BUILDING RENOVATION FOR LINCOLN OLIVER	
LINCOLN OLIVER - NICHOLS, RAYSON	
DATE: 5-7-73	DESIGNED BY: T. R. R. T. R. T.
3408 D. L. SIMMONS, NICHOLS, RAYSON	1-2

BZA 10-73

LANDO CORP. LINCOLN & OLIVER	
Kichita, Kansas	
DATE 8-7-73	DESIGNED BY
DRAWN BY	
CHECKED BY	
APPROVED BY

SITE PLAN 1/8" = 1'-0"

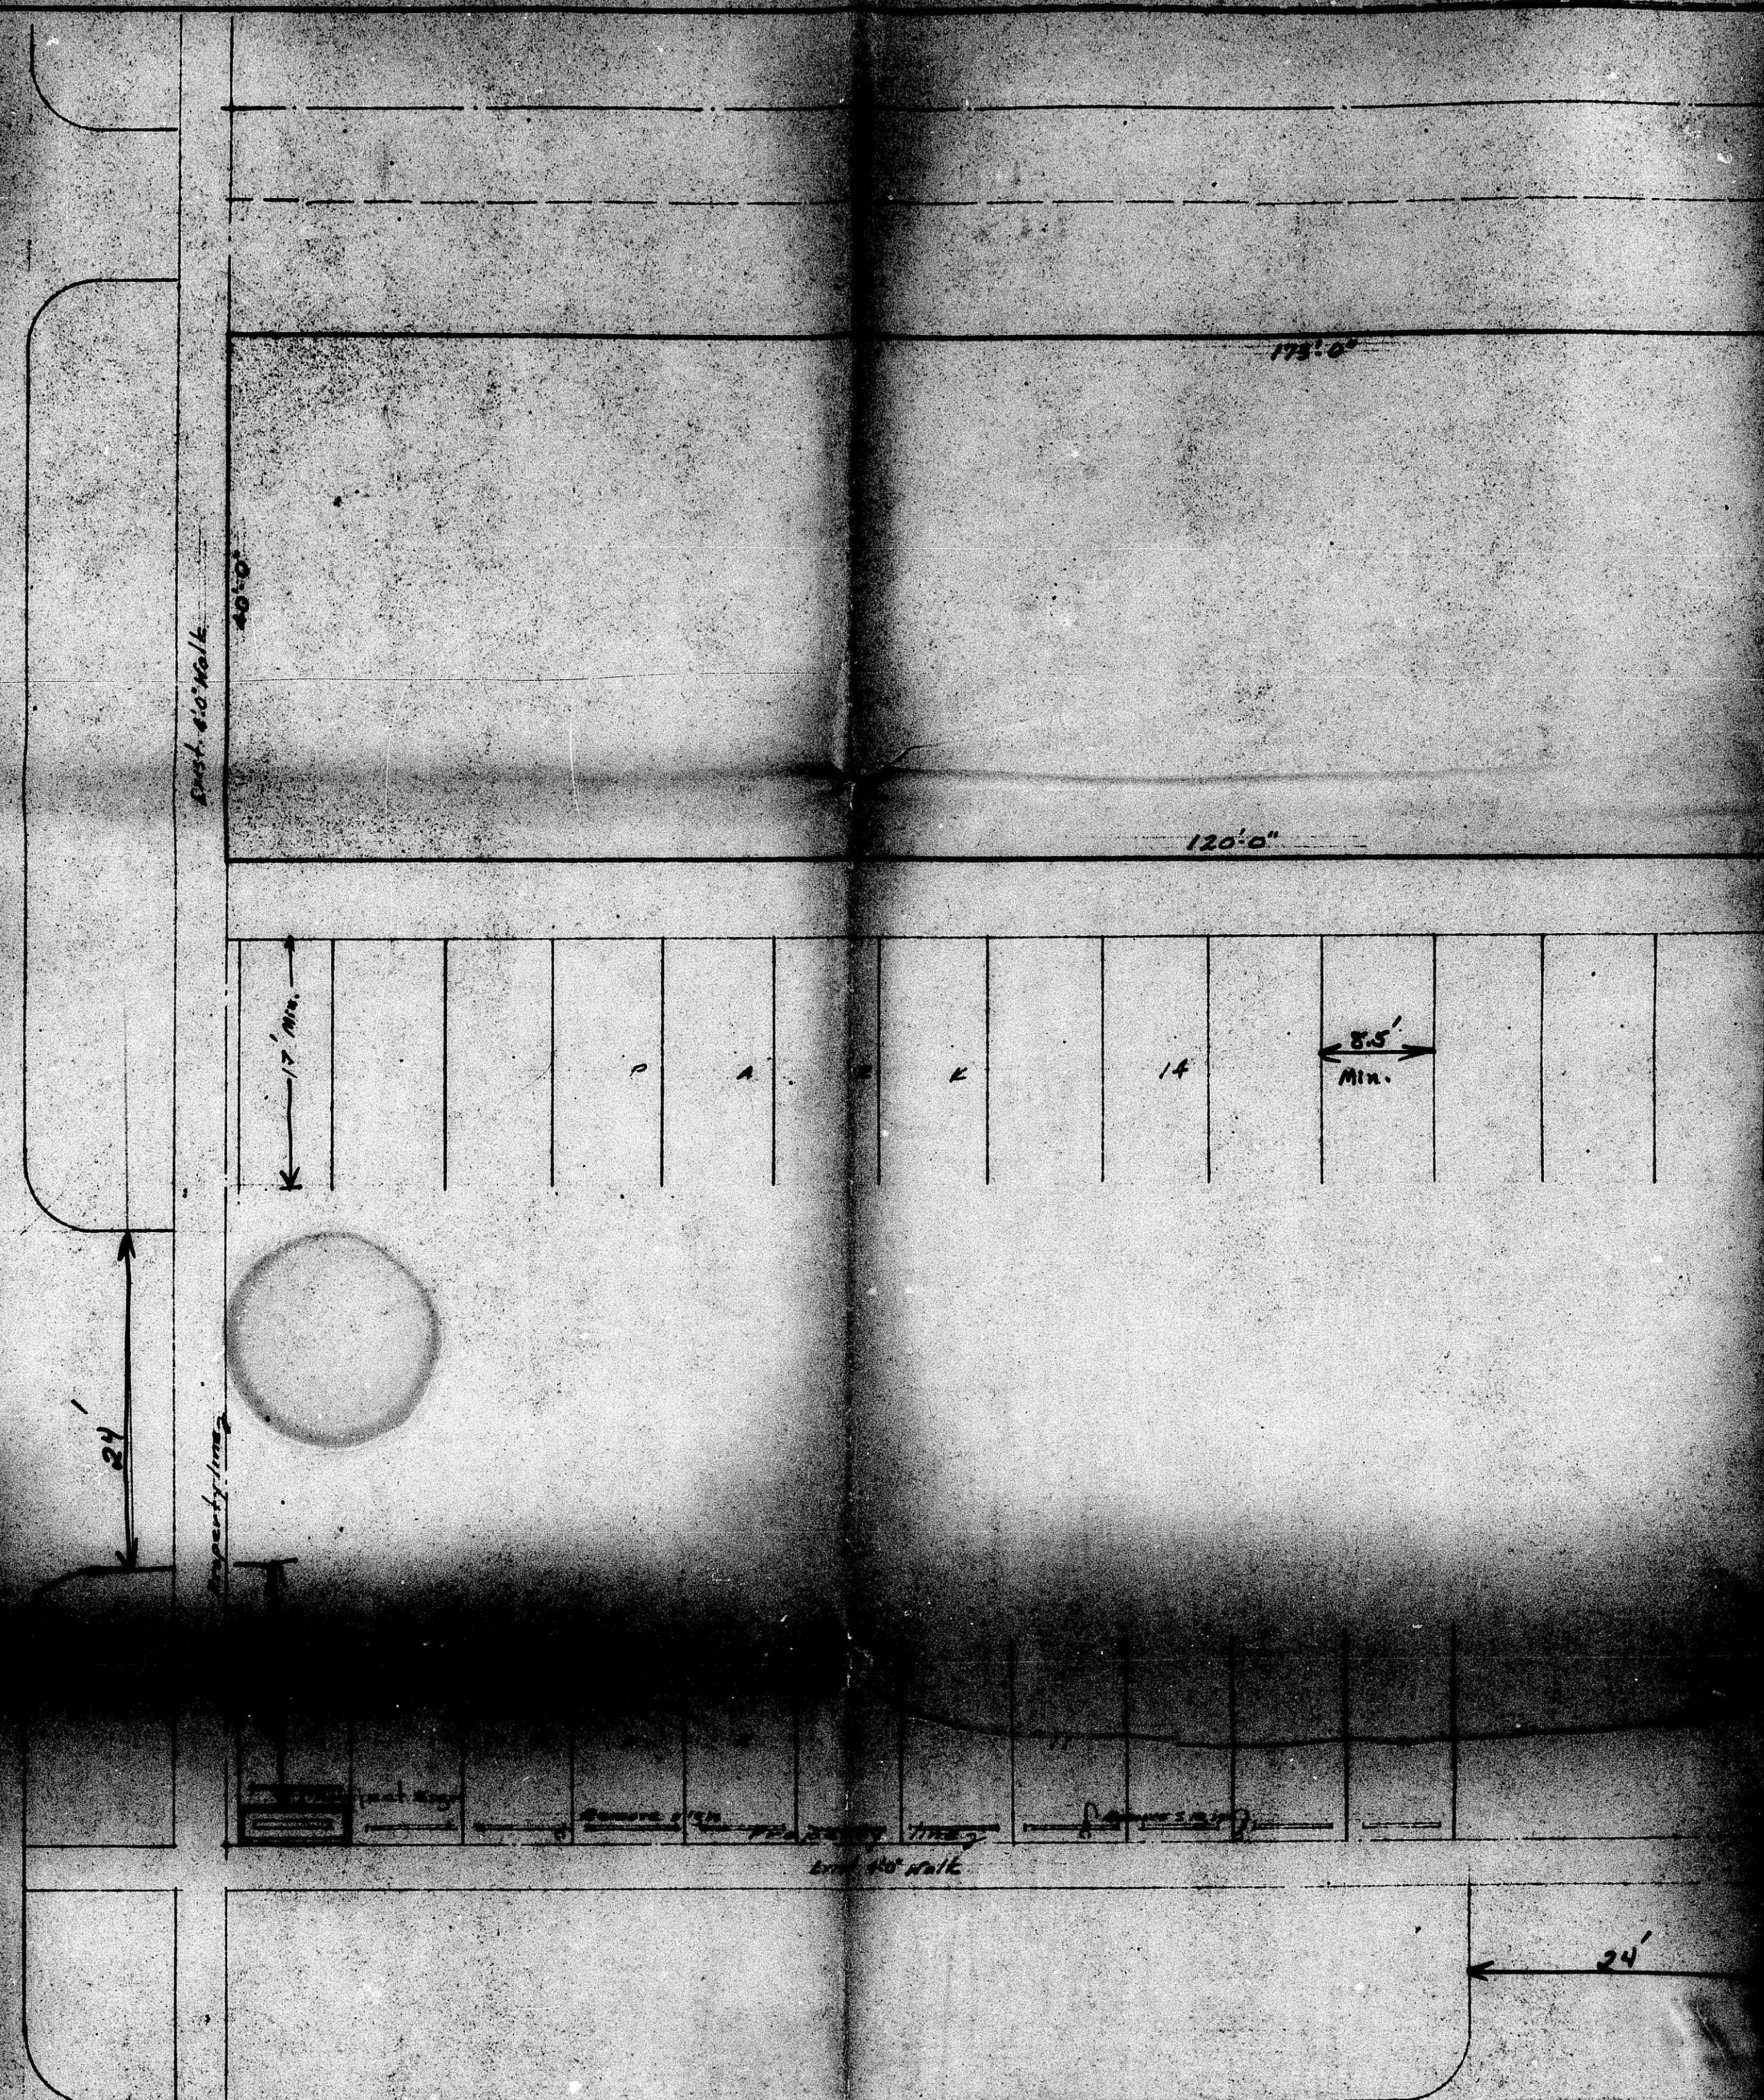
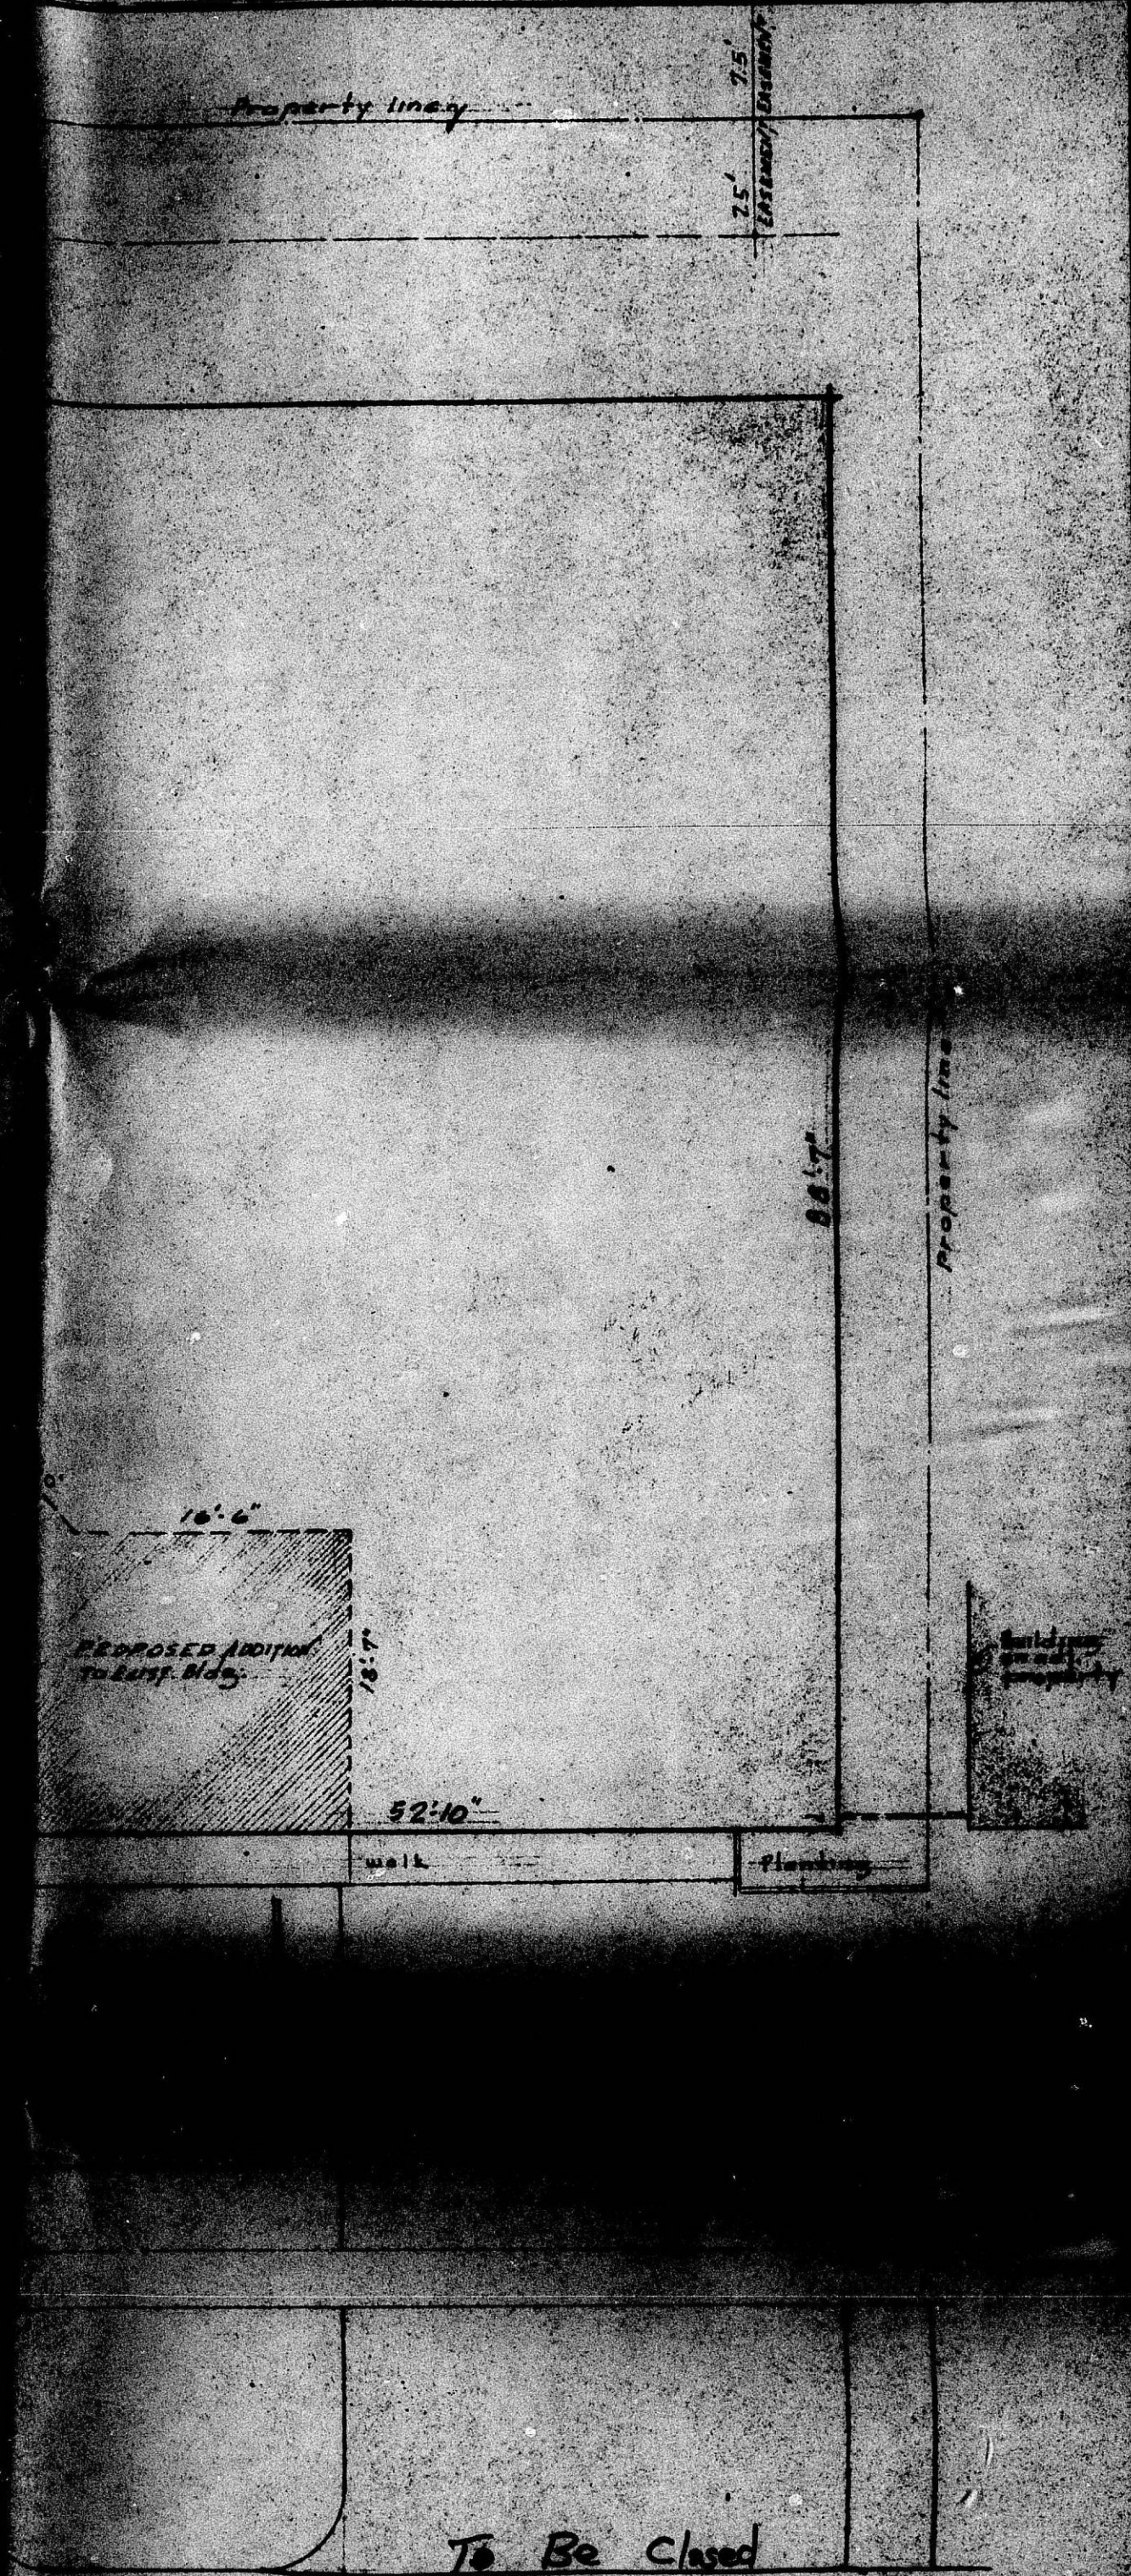
The parking arrangement is approved
and as to geometrics as noted (for 27 spaces)
However 27 spaces are required; therefore
this parking layout does not have final
approval of the Traffic Eng. Div.
